Illustrated Parts List - IPL Update

H560XP/XPG

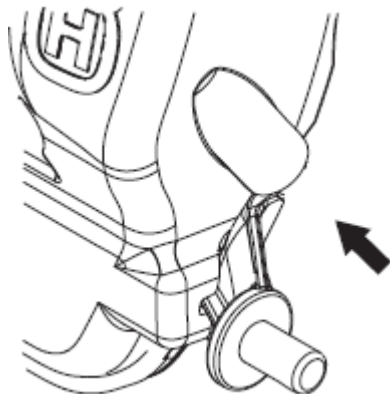
1. A new Filter holder, assy: 525 39 79-05 (standard) has been introduced. No nipple, hole removed to improve the startability.
The same change has been made on Filter holder, assy: 525 39 79-06 (heat).
2. A new Hose kit 589 35 71-01 replace the Hose 587 64 54-02. The new kit can be used for both new and old models regardless of which generation of filter holder the user have.
3. A new Hose 587 64 54-04 added for the new filter holders without nipple.
